2nd Further Information

Proposed Temporary Shop and Services and Public Vehicle Park (Excluding Container Vehicle) with Ancillary Facilities and Associated Filling of Land for a Period of 5 Years in “Village Type Development” Zone, Lot 354 in D.D. 112, Shui Lau Tin, Shek Kong, Yuen Long, New Territories

(S.16 Planning Application No. A/YL-SK/433)

Response-to-Comment (RtC)

FIGURE NUMBER
FIGURE 3

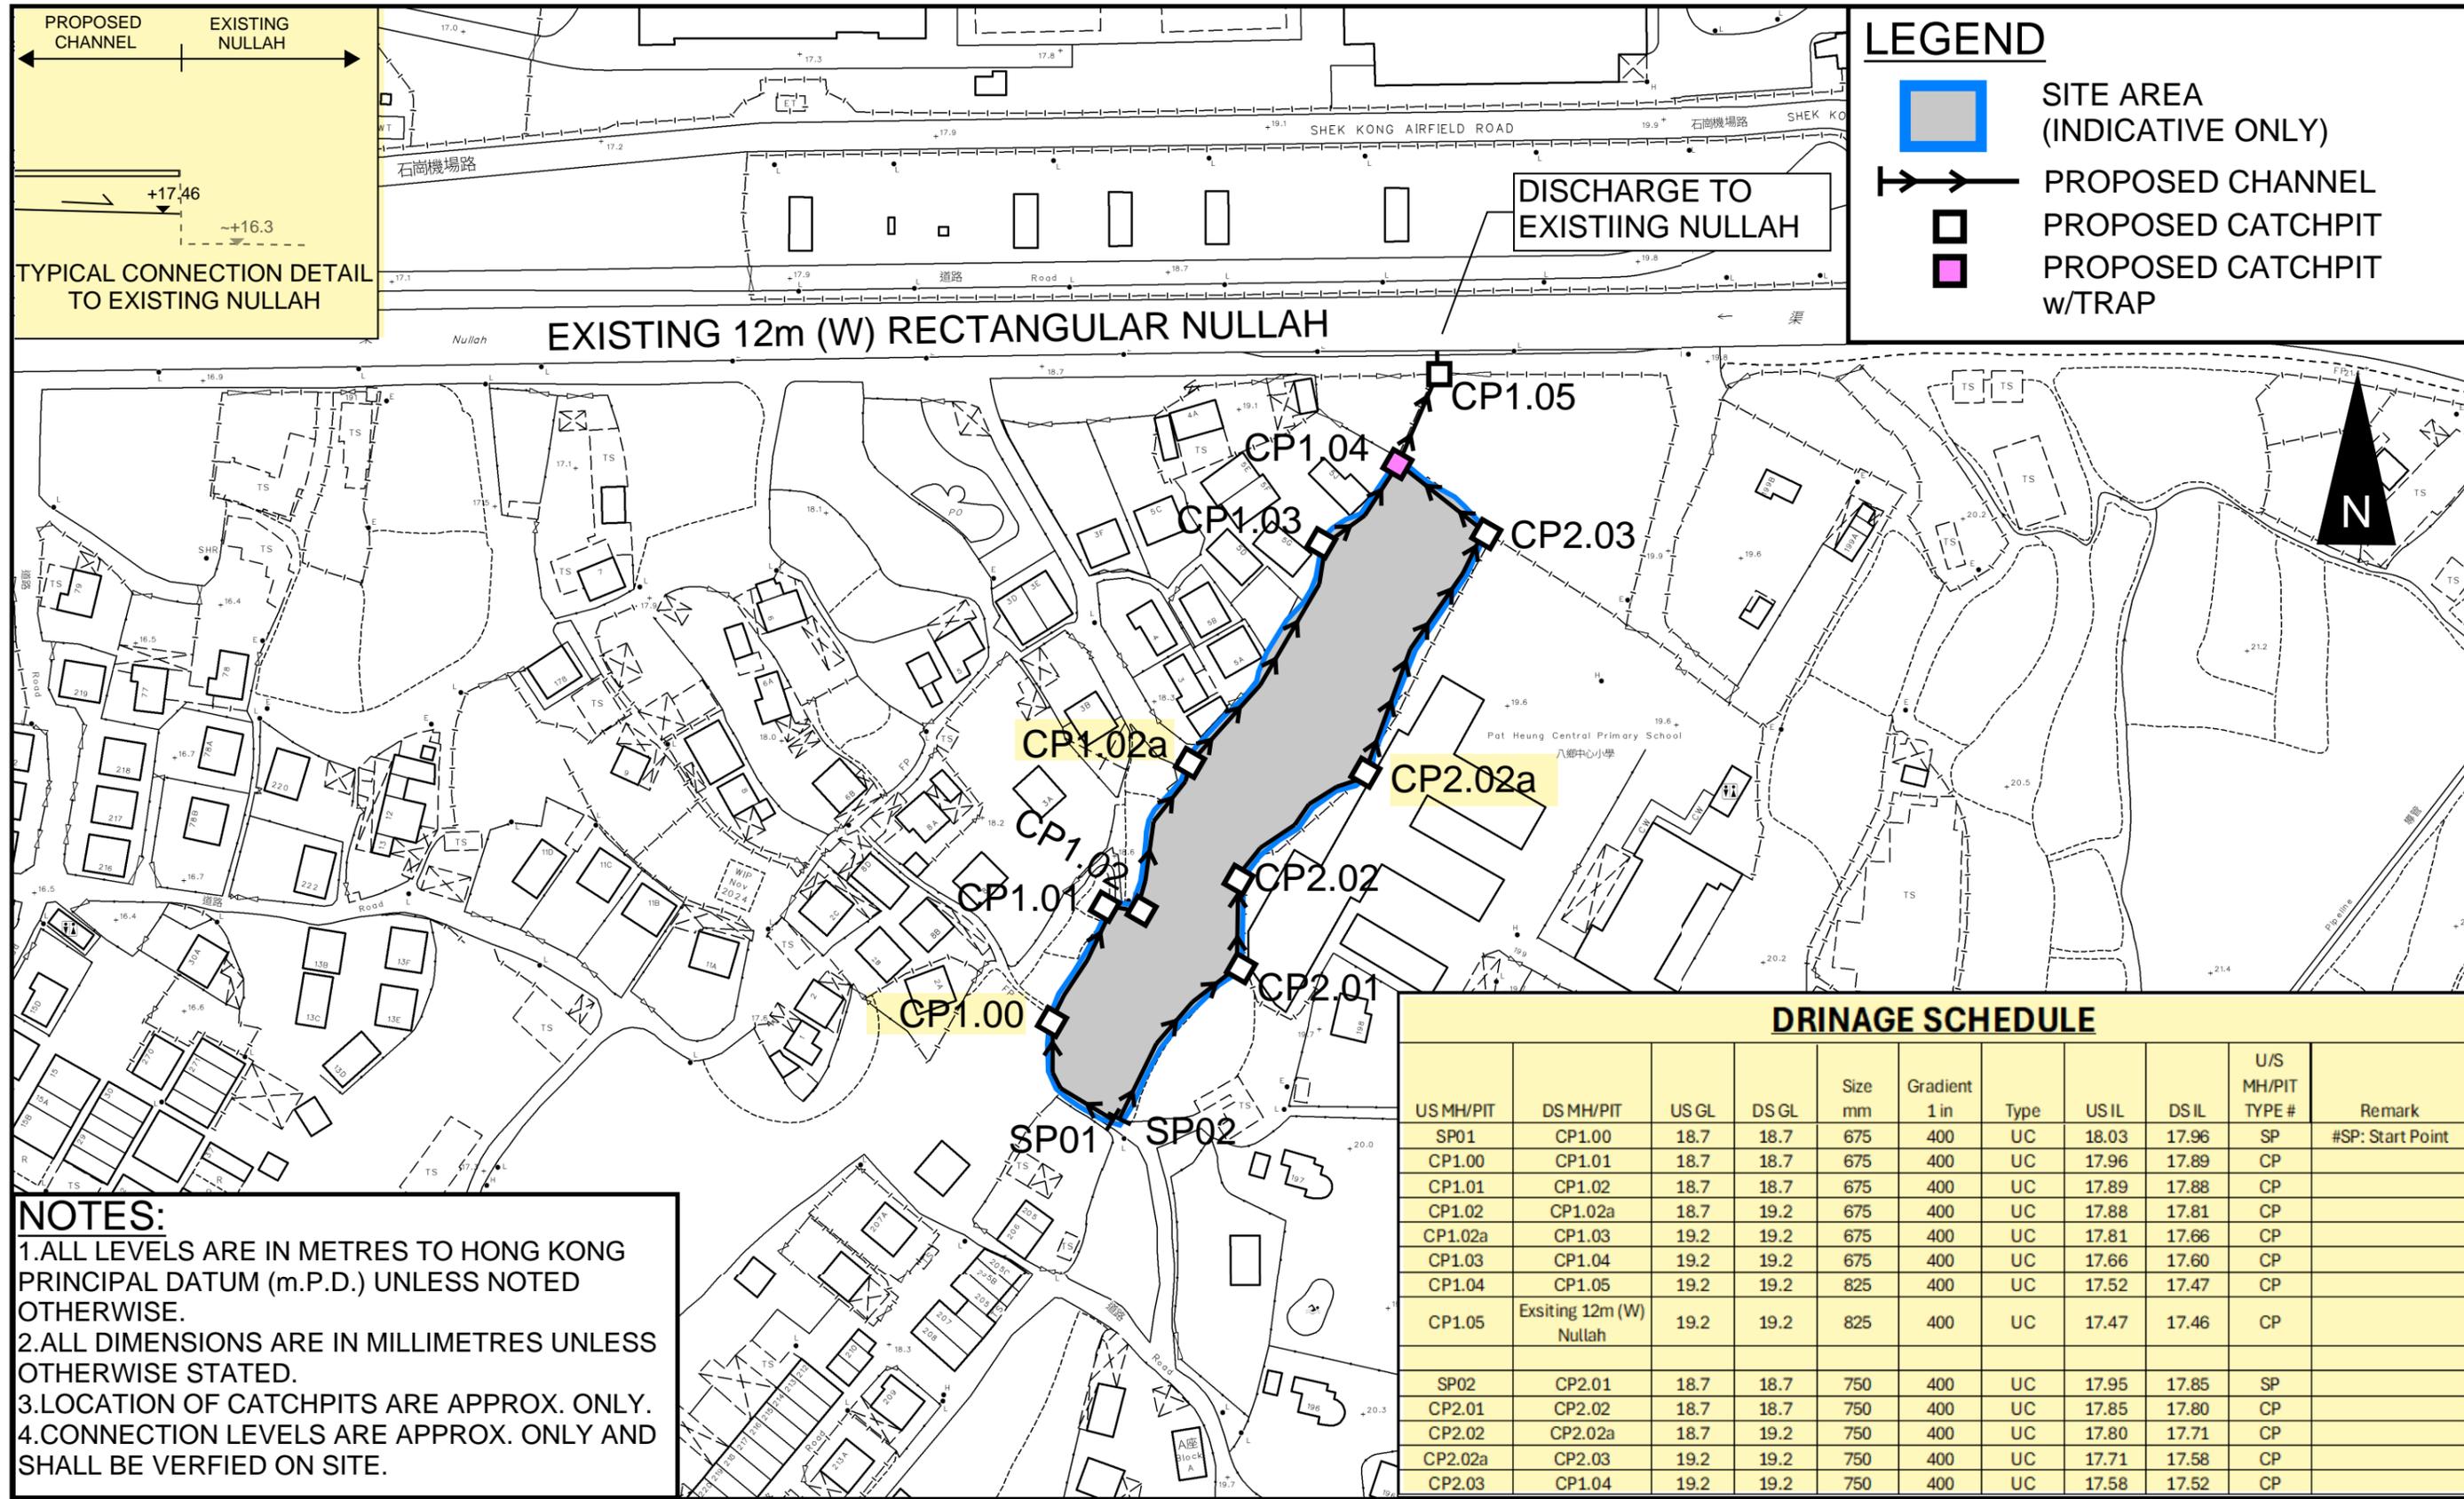
| Departmental Comments | | Applicant's Responses |
|----------------------------------------------------------------------------------------------------|-----------------------------------------------------------------------------------------------------------------------------------------------------------------------------------------------------------------------------------------------------------------------------------------------------------------|-------------------------------------------------------------------------------------------------------------------------------------------------------------------------------------------------------------------------------------------------------------------------------------------------------------------------------------------------------------------------------------------------------------------------------------------------------------------------------------------------------------------|
| (b) | Catchpit should be provided at the turning point of the proposed u-channel. | Noted. Please refer to the updated Figure 3 in the enclosed drainage proposal. |
| (d) | Please provide the connection details to the existing 12m width channel for review. | Noted. Please refer to the updated Figure 3 in the enclosed drainage proposal. |
